Note to editor/reviewers. Plain text represents the original comment, and bold text represents the response.

Reviewer 3

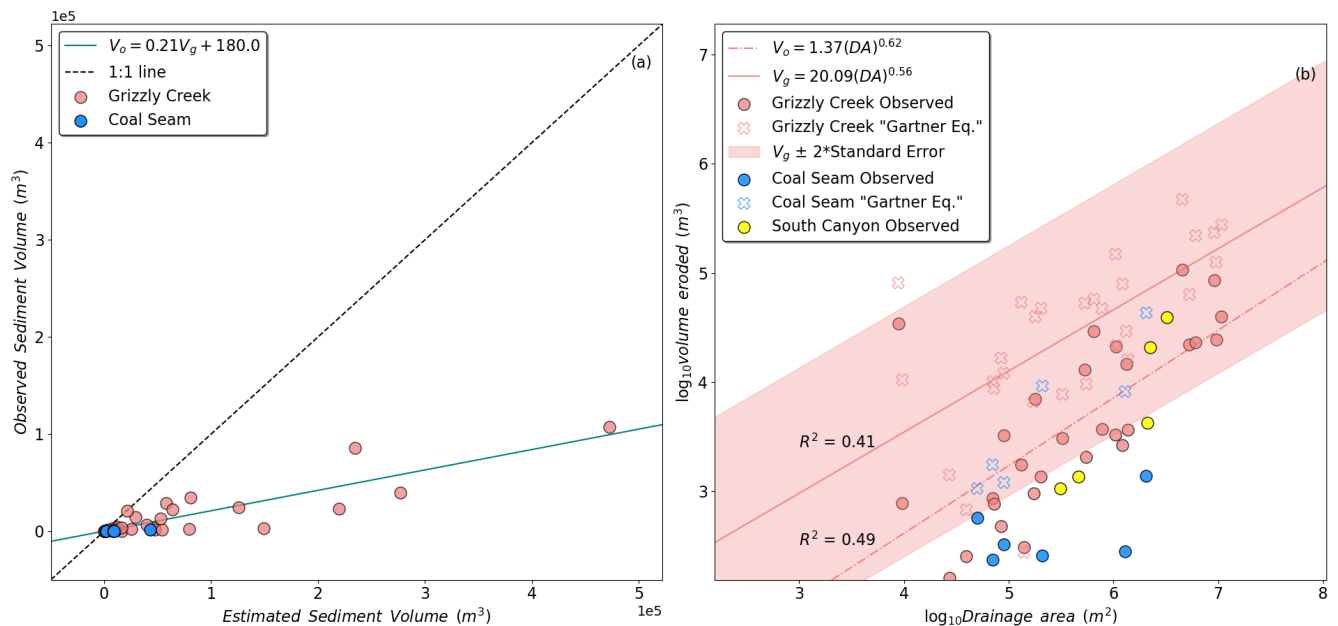
Fig 9A: The 1e5 scientific notation next to axis labels is too small. Consider blowing up this text or adding it alongside the units (e.g., 1e5 m³).

Fig 9B: I think the power law fits could be better coordinated with their respective point grouping colors – why have a Vp blue power law fit that does not match corresponding points with open red x's and Vo black dashed fit that does not match red circles. Also, these power law fits do not visually seem to fit their respective datasets very well. Additionally, it would be good to provide an estimate of goodness of fit metric (R²) as well as p-values (or confidence intervals) for regression parameters (prefactor and exponent) to provide some degree of confidence of these fits.

Additionally, for Fig 9B and the comparison between Coal Seam observed vs predicted (Line 360 earlier), do you see a similar ~4-fold overprediction from the Gartner et al. (2014) model? If it was close to this value, it further supports using this as a regional correction factor.

I increased the fontsize for clarity. See new version of figure below in response to next question.

Some very good suggestions here. First, regarding colors, we agree, this can be improved. I think we have now simplified the colors to make it more clear. Here our revised logic for the new color choices. We are only fitting a line to the volumes predicted and observed at Grizzly Creek. We are then

superimposing the Coal Seam and South Canyon data points to show how they compare. Therefore, because we use the red/pink color for Grizzly Creek data, we've made the power-law fit lines red/pink as well. We just use different line styles to differentiate them. We have also changed the color of the South Canyon Fire data to yellow from black, so that it isn't confused as having a relationship with the lines in Figure 9a.

As for powerlaw fit. We agree that the fit isn't great, and that the data don't conform to the assumptions of a normal distribution. Therefore, reporting a p-value doesn't really make sense. However, we do report the R² values on the plot now (see below) and show +/- 2 standard error, which should capture 95% of the data.

Because of the incoming data for the South Canyon Fire, we don't have sufficient information to generate a volume estimate using the Gartner equation, which we state with this text:

Consequently, we can't say for certain the magnitude of the overprediction without applying Equation 2. However, we clearly see that the South Canyon observations are in-line with the observations made at the Grizzly Creek Fire. For the Coal Seam Fire, overpredictions range from 1.8x to 35x compared to the observations. Of the 6 observations, three of the overpredictions from the Gartner equation are <7.3x, and the other three observations are between 29x-35x. To highlight these differences to readers, we have added the following sentence to the discussion:

"The Coal Seam debris-flow volumes were overestimated between 1.8-35 times by Equation 2."
